Access Compliance Report

Public Rights-of-Way (Curb Ramps)

Intersection ID: 46499	Main Street: WHITEBURN_CT	Cross Street: BALTRAY_RD	Location: NE
ADA ID: D37C373E48E9	Ramp Type: PerpDiag	Initial Pass/Fail: Fail	Overall Compliance: No
		Severity Score: 8.75

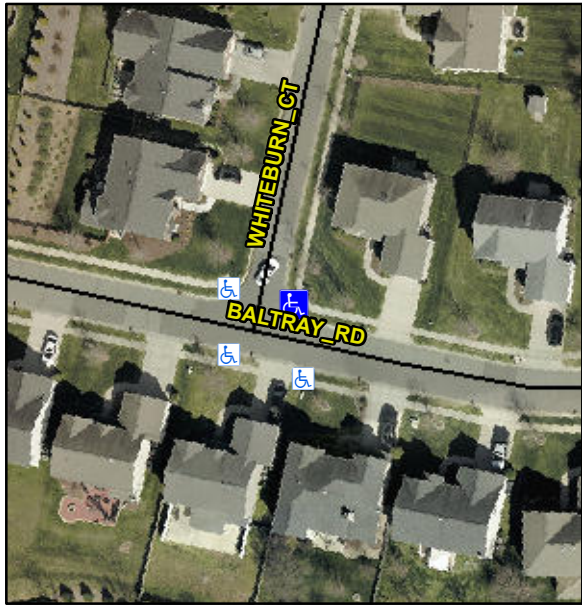
Codes/Mitigation Info/Possible Solution			Field Measurements/Component Compliance					
	Possible Solutions:		Compliance	Description	Data	Compliance	Description	Data
	Remove & Replace Curb Ramp With Two New Directional Ramps or Equivalent.		N/A	Ramp Length (in)	50.0	Yes	Ramp Slope (%)	6.6
			No	Ramp Width (in)	46.5	Yes	Ramp XSlope (%)	1.2
			N/A	Flare Type LT	N/A	N/A	Flare Type RT	N/A
			N/A	Flare Slope LT (%)	N/A	N/A	Flare Slope RT (%)	N/A
			N/A	Flare Traversable LT?	N/A	N/A	Flare Traversable RT?	N/A
			N/A	Landing Length (in)	N/A	N/A	DWS Provided?	N/A
			N/A	Landing Width (in)	N/A	N/A	DWS Contrast?	N/A
			N/A	Landing Slope (%)	N/A	N/A	DWS Length (in)	N/A
			N/A	Landing X Slope (%)	N/A	N/A	DWS Full Width?	N/A
Surveyor Notes: N/A			N/A	Landing Curb? (Y/N)	N/A	N/A	DWS Offset (in)	N/A
			N/A	Shared Landing?	N/A			
			N/A	Gutter Ponding?	N/A	N/A	Gutter Slope (%)	N/A
			N/A	Gutter Lip Ht (in)	N/A	N/A	Gutter X Slope (%)	N/A
